# JOINT REGIONAL PLANNING PANEL (Hunter and Central Coast)

## Council Assessment Report

Panel Reference	PPS-2016HCC020
DA Number	DA 49565/2016
Local Government Area	Central Coast Council
Proposed Development	Mixed Use Development – Commercial and Shop Top Housing (2 Towers) Residential Flat Building (4 towers)
Street Address	Lots 1, 2, 3, 25 & 26 Sec A DP1591, Lots 4 & 5 DP15954, Lot 31 DP553523 and Lot 2A DP407164,  Nos 372, 374, 393, 395 & 397 Mann Street, Nos 35, 37 & 41A Dwyer Street and No 76 Hills Street, North Gosford
Applicant	Caine King - CKDS Architecture (note that the site owner Ken Schmidt has requested to be the applicant via email dated 12 July 2020)
Owner	K Schmidt
Date of DA Lodgement	31 March 2016
Number of Submissions	First round - 33 submissions, petition with 55 signatures  Second round - 15 submissions, petition with 122 signatures.  Third round - 25 submissions, petition with 121 signatures  Fourth (final) round - 18 submissions, petition with 121 signatures.
Recommendation	Refusal

**Figure 27- Inappropriate areas of Communal Open space to Towers 5 and 6, and instances of 'corner units' not achieving natural cross ventilation, given small windows size, path of travel and as windows face in same general direction**

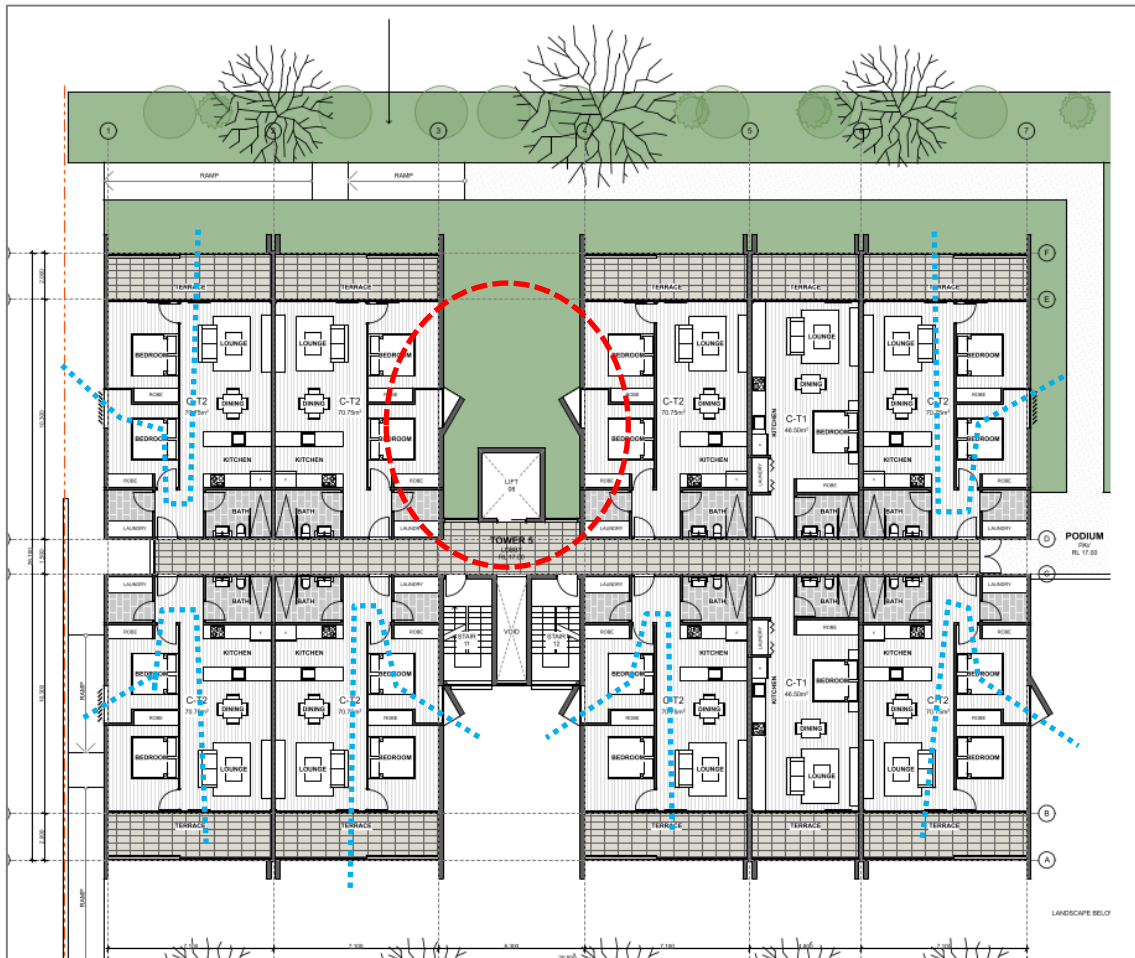
No figures or calculations of natural cross ventilation have been provided, while it appears that Towers 1-4 wold achieved a good level of naturally cross ventilation, Towers 5 and 6 appear to achieve poor levels of natural cross ventilation. It is noted that even the 'corner' units on the lower levels of Towers 5 and 6 have only small angled widows on the side elevation that face the same direction as the primary windows, thereby not creating a pressure differential for cross ventilation (refer Figure 27). In addition to this the location of communal open space and bedroom windows within Towers 5 and 6 result in a poor visual and acoustic privacy amenity outcome (refer Figure 27).

Both main communal open spaces areas are located to the south of buildings and are unlikely to achieve required solar access or good amenity outcomes and some balconies are identified as being undersized.

Design Criteria	Required	Proposed	Compliance
<b>3D-1 Communal Open Space</b>	Minimum communal open space area 25% of the site	<p>A diagram showing areas included in COS calculation not provided.</p> <p>The landscape plans give the total soft landscaping area as 2,657sqm, which is 25% of the total site area. But all soft landscaping is not COS.</p> <p>There is approx. 500sqm COS on the eastern site 'pool area' and approx. 770sqm provided on the western site 'pool area'. This equates to approx. 12% of the total site area.</p> <p>Further areas identified as communal open space to the front and rear of Towers 5 and 6, while providing additional usable COS, also locate COS directly adjacent to bedroom windows, which is not acknowledged on the landscape plans and is inappropriate from a visual and acoustic privacy perspective. The areas are also located in building indents that would not provide pleasant or usable space (See Figure 27).</p>	Not demonstrated
